Acorn

Activities / Amenities

JQP, Inc. Recommends

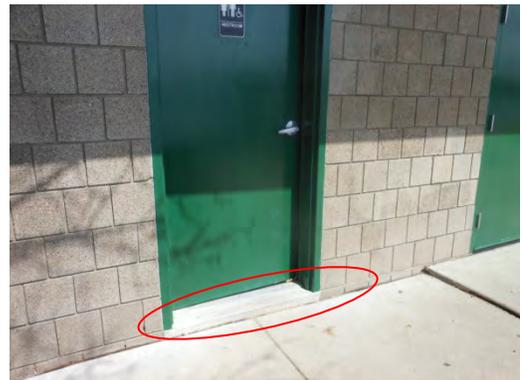
There is currently a 3" change in level at the entry.

Priority 2- Modify the entry so the change in level is 1/2" maximum. ADA 302.3, 303.1

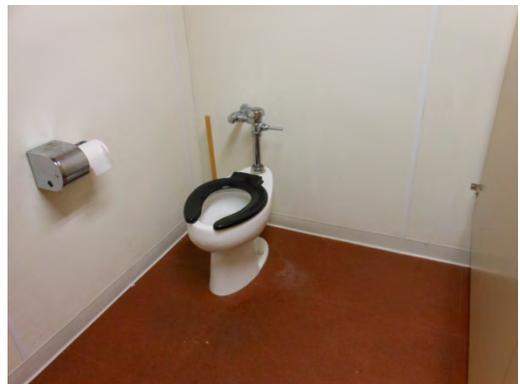
The toilet rooms in the shelter are large enough to provide features of accessibility. Grab bars are not currently installed.

Priority 2- Install grab bars. MN1341 604.5

Priority 2- Replace the locking hardware on the stall door. MN1341 604.8.3

Priority 3- Lower the urinal in the men's toilet room to 17" maximum (currently 24"). MN1341 605.2

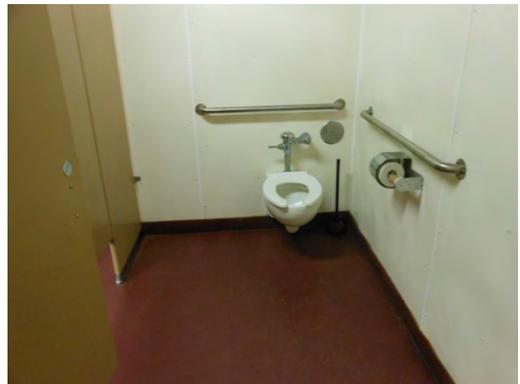
The toilet rooms in the shelter provide many features of accessibility. Vertical grab bars are not currently installed.

Priority 2- Install vertical grab bars. *MN1341 604.5*

Priority 2- Replace the locking hardware on the stall door. *MN1341 604.8.3*

Priority 2- Add signs with raised and braille characters to the interior and exterior entries to the toilet rooms.
